## **NOTICE OF APPROVAL OF AMENDMENTS TO THE JUNE 2017 DELAY ATTRIBUTION PRINCIPLES AND RULES**

## Schedule of approved amendments to the June 2017 Delay Attribution Principles and Rules

K9 Flowchart covering signalling delays in ARS and TMS controlled areas. Any delays caused by schedules that are not compliant with the Capacity Planning Rules (i.e. don't work) should be dealt with under Section L

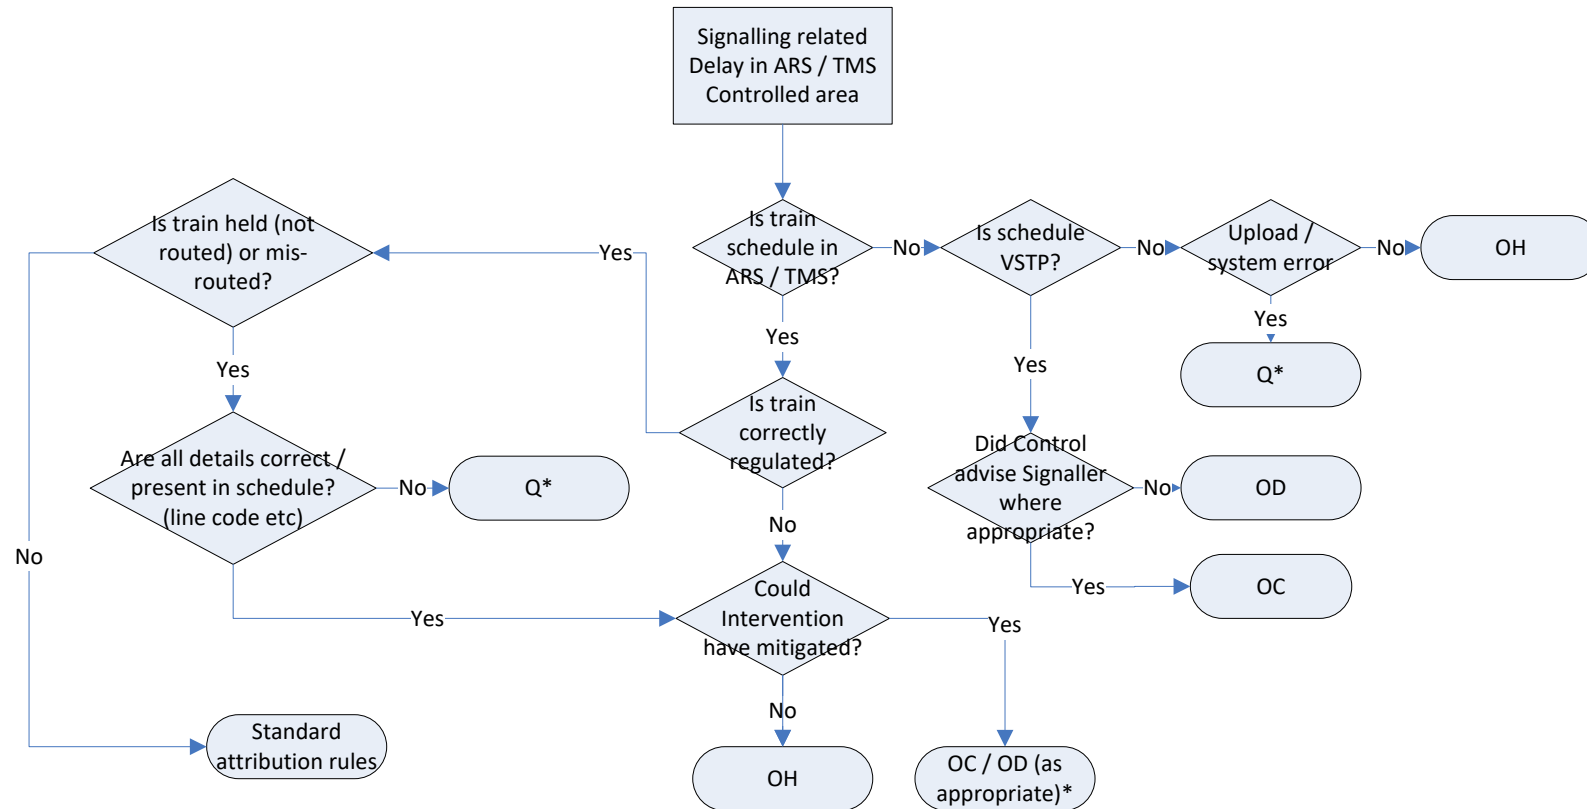
**NR/P194 - Traffic Management**

**1. Replace current DAPR K9 with that as shown below:-**

\*Note – OC / OD dependent on system and person who controls the regulation
